3933 Quail Ridge Road Residential Project

Final Environmental Impact Report

SCH#2019071038

2 Responses to Comments on the Draft EIR

Log of Boring LD-1, 40 to 70 Feet
Quail Ridge Road
Lafayette, California

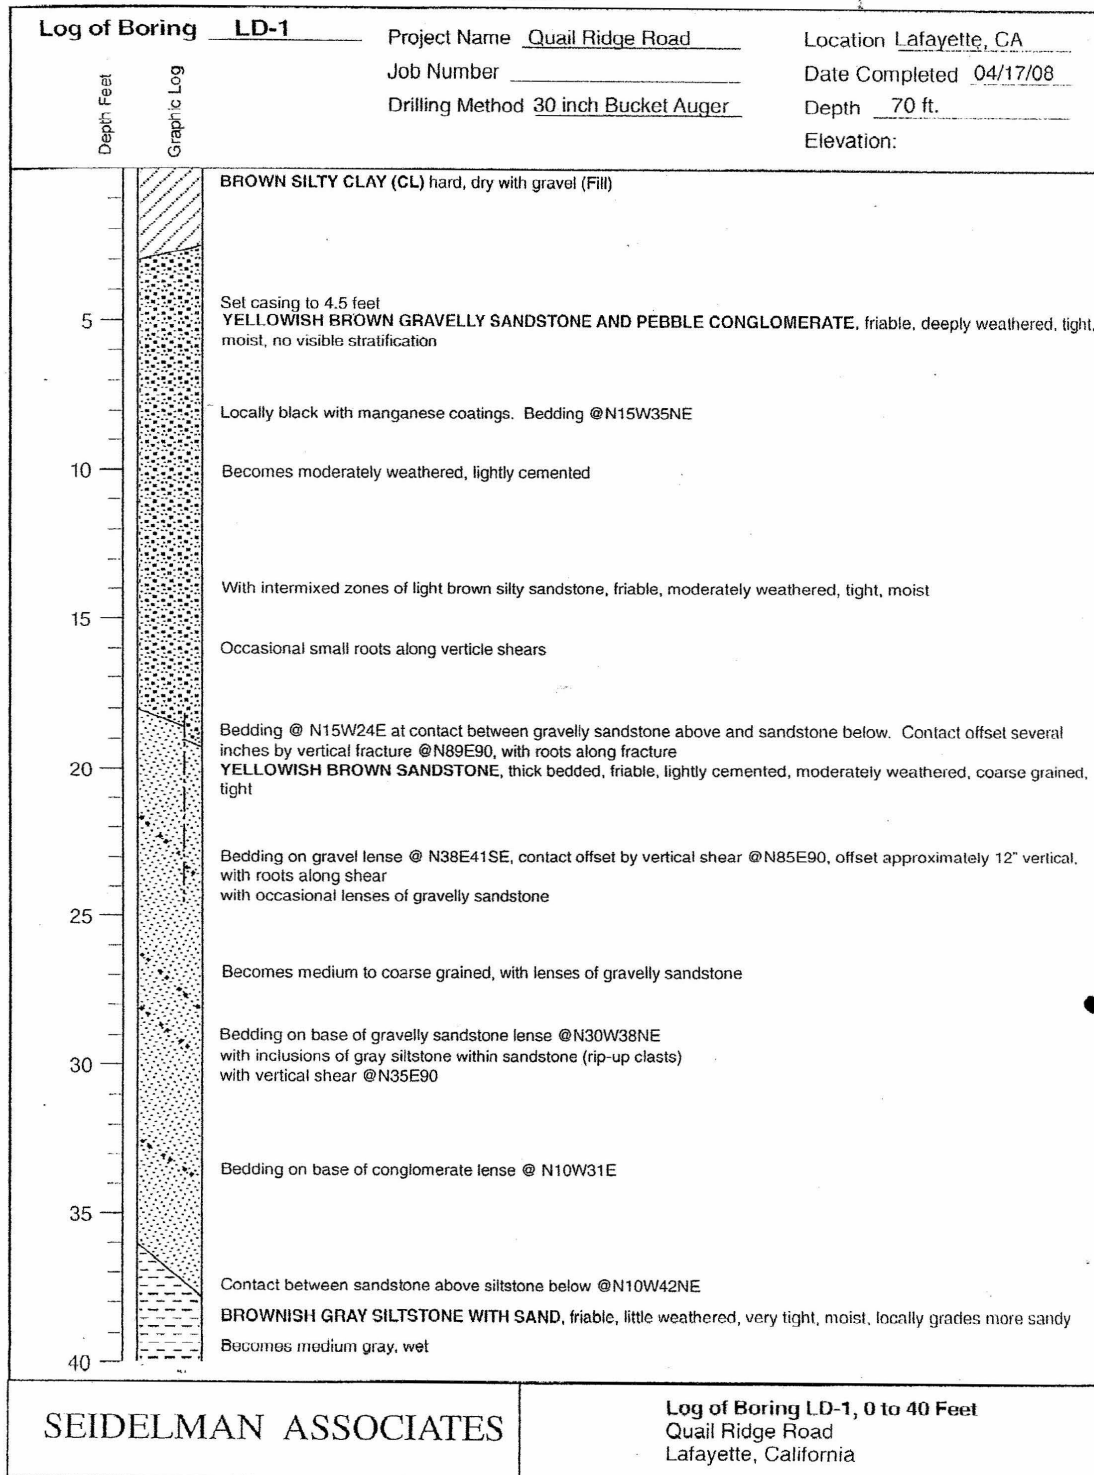
Dear Ms. Tran: I am submitting my comment on the draft EIR for the proposed 3933 Quail Ridge Road Residential Project dated March 20, 2020. My comment is related to the potential impact of the discontinuities (weak clay seams) located at depths of 51 to 55 ft and 66 to 68 ft on the feasibility of the proposed building site not being adequately addressed by the draft EIR (see Appendix B-13 of the draft EIR). The discontinuities were discovered by a large borehole done by Seidleman Report dated June 24, 2008 (Appendix B-7, see Attached Log of Boring LD-1). The letter report dated August 14, 2012 by GeoForensics (Appendix B-12) raised the concern of these clay seams on the stability of the proposed site.

The commenter questions the potential impacts of discontinuities (weak clay seams) located at depths of 51 to 55 feet and 66 to 68 feet, noted on the log of the large diameter boring LD-1 from the Seidelman Report dated June 24, 2008 and based on questions raised in the GeoForensics letter report dated August 14, 2012.

GeoForensics raised the question of a potential instability underlying the northeast corner of the site in an August 14, 2012 letter based on their interpretation of two clay seams shown on the log of the large diameter boring LD-1. The subject clay seams were noted at depths of 51 to 55 feet and 66 to 68 feet bgs. GeoForensics references speaking with Mr. Joyce who logged the boring and the City's reviewing geologist who informed him that the subject clay seams were tectonic in nature and not related to the landslide conditions at the site. Tectonic shears are extremely common in the area due to compressive forces of fault systems. Their presence can impact a site; however, their orientation is the critical component of that consideration.

GeoForensics questions if the clay seams could develop into large landslide based on the fact that at least one of the shears dips downslope (towards the active landslide). This interpretation of the log of LD-1 by the engineers at GeoForensics is incorrect, as the shears noted on the log of LD-1 dip to the northeast, into the slope. The Log of LD-1 shows clay seams at 51 to 55 feet bgs and 66 to 68 feet bgs. The range in depth reflects a dipping plane and not 2- to 4-foot sections of clay. The clay seam between 51 to 55 feet bgs is described as "Shear Zone, light gray clay seam 1/8" thick @ N75W65NE" and labels the seam a second time with the orientation of N73W54NE. This nomenclature indicates that the 1/8-inch thick clay seam is oriented striking 73 to 75 degrees west of north and dips to the northeast at an inclination between 45 and 65 degrees. Between 66 and 68 feet bgs, the log shows the second clay seam as "Shear zone consisting of 1.5' thick gray clay seam N20W 47NE". Again, this indicates that the 1.5-inch thick clay seam dips to the northeast into the hill. In comparison, the Quail Ridge Landslide failed in the southerly direction; therefore, tectonically-created clay seams dipping to the northeast into the hillside do not decrease stability of the site.
